ENGINE - LP COMPRESSOR - TO IMPROVE REMOVABILITY OF INNER RACE ON THE PTO SHAFT -
CATEGORY CODE 6 - MOD.ENG-72-0214

V2500-ENG-72-0214

SERVICE BULLETIN

Location of the Inner Roller Bearing
Fig.1

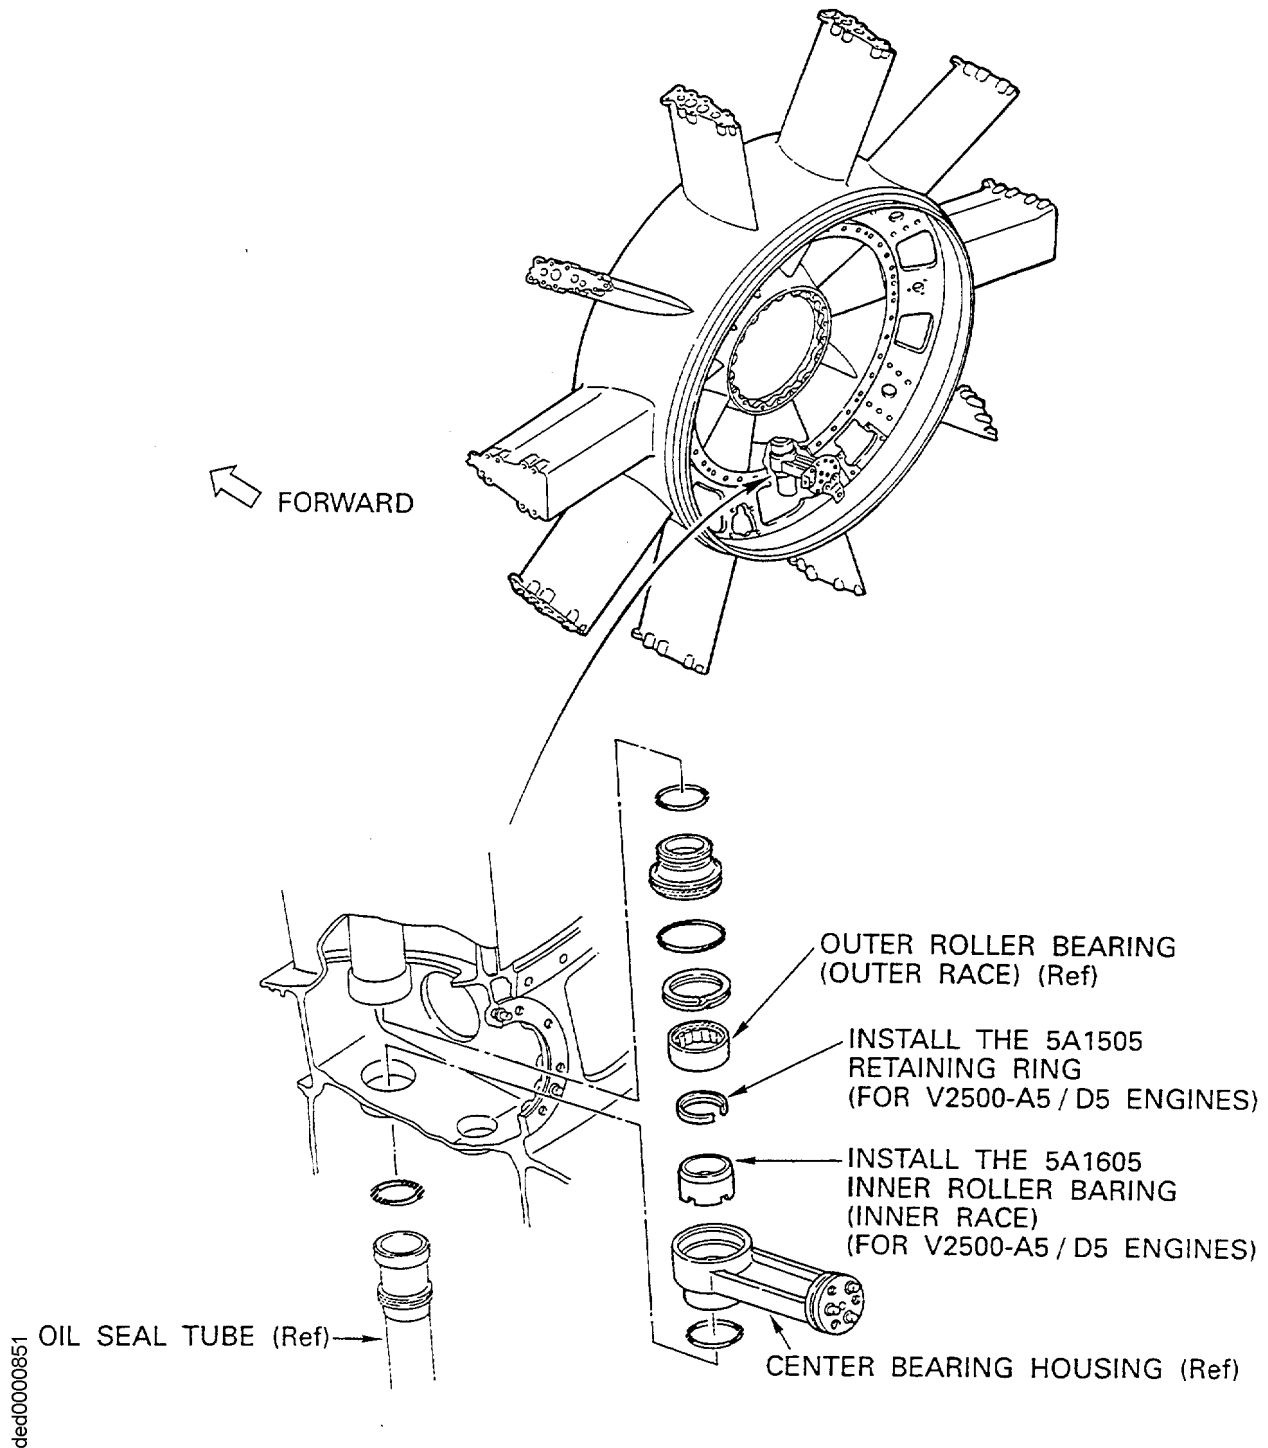
- (a) The new 5A1605, Inner Roller Bearing (Inner Race) will be introduced to increase number of squeezing slots from four to eight (See Figure 1).
- (b) The new 5A1505, Retaining Ring will be introduced to reduce free diameter of the ring (See Figure 1).

Install the 5A1605, Inner Roller Bearing (Inner Race) and the 5A1505, Retaining Ring by the approved procedures in Reference L.(2) Chapter/Section 72-32-00, Assembly-11 (Refer to Figure 1).
